SUBJECT: COMANCHE PEAK STEAM ELECTRIC STATION (CPSES)  
DOCKET NOS. 50-445 AND 50-446  
TRANSMITTAL OF COMMENTS ON THE  
PROOF AND REVIEW COMMON TECHNICAL SPECIFICATIONS

REF: NRC Letter from Mr. Brian E. Holian to  
Mr. William J. Cahill, Jr. dated July 1, 1992.

The proposed changes include; 1) corrections to validated Unit 2 values, 2) corrections reflecting previously transmitted changes, and 3) a revised testing frequency for turbine overspeed protection. Attachment 1 provides the descriptions/justifications for the proposed changes. Attachment 2 is a markup of the "Proof and Review" Technical Specifications denoting the proposed changes. Please note that Amendment 11 to the CPSES Unit 1 Technical Specifications have not been incorporated into the Proof and Review copy.

ATT Valve Testing Interval

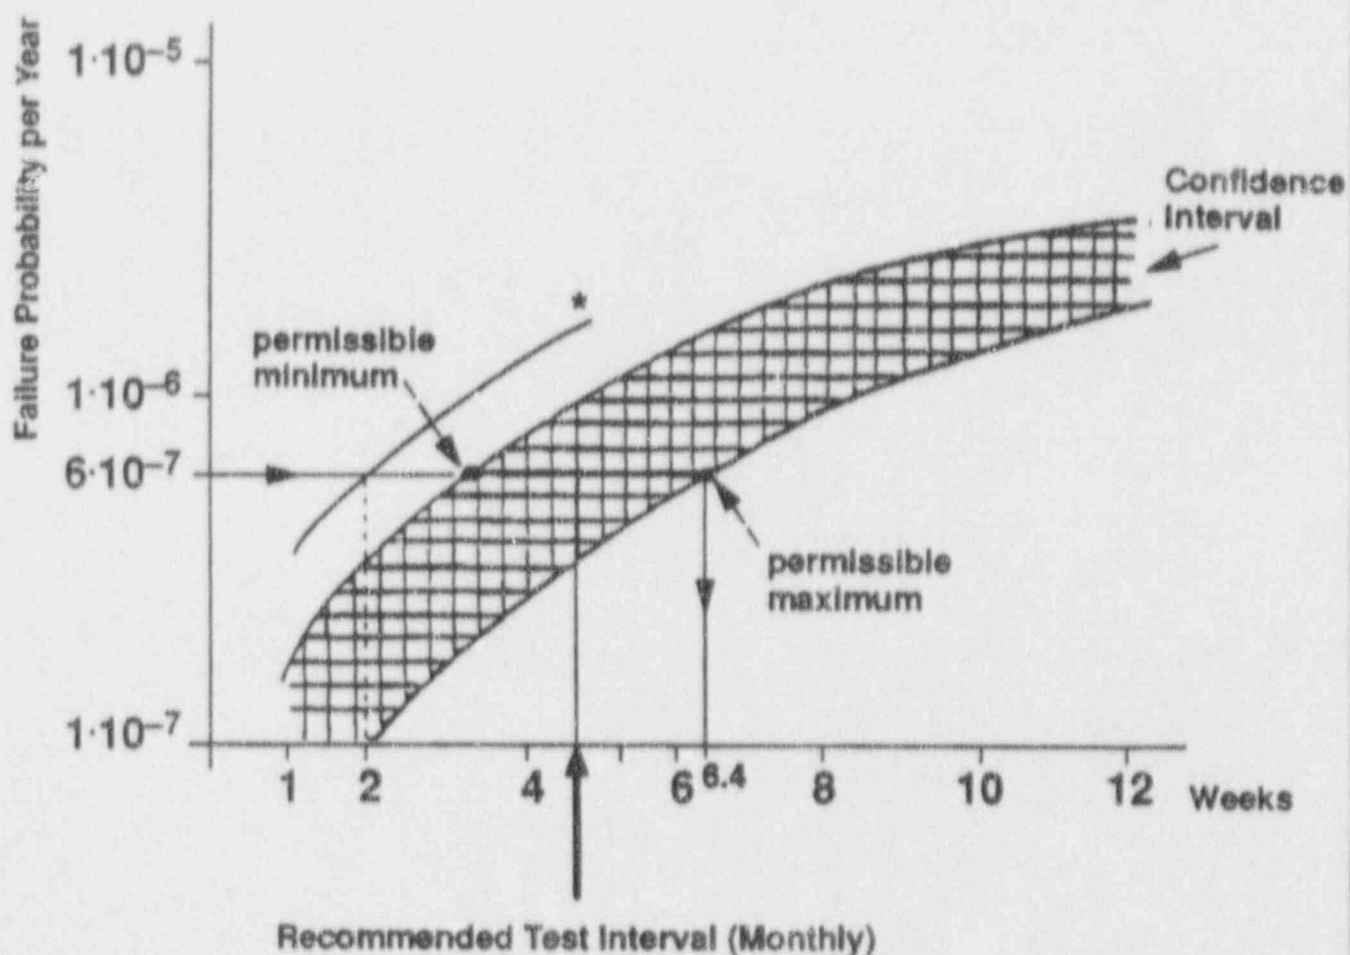
Siemens, the manufacturer of the CPSES turbines (Units 1 and 2), has recommended a one month testing interval, or a six week testing interval providing, that additional monitoring sensors are installed on each stop valve, and that no degradation of closing time is observed. This recommendation was based on a quantitative evaluation performed by Siemens on the probability of failure of the HP/LP turbine stop and control valves as a function of their test interval (see attached figure). CPSES intends to install the additional monitoring sensors and monitor valve closing time

degradation prior to implementation of a six week testing interval.
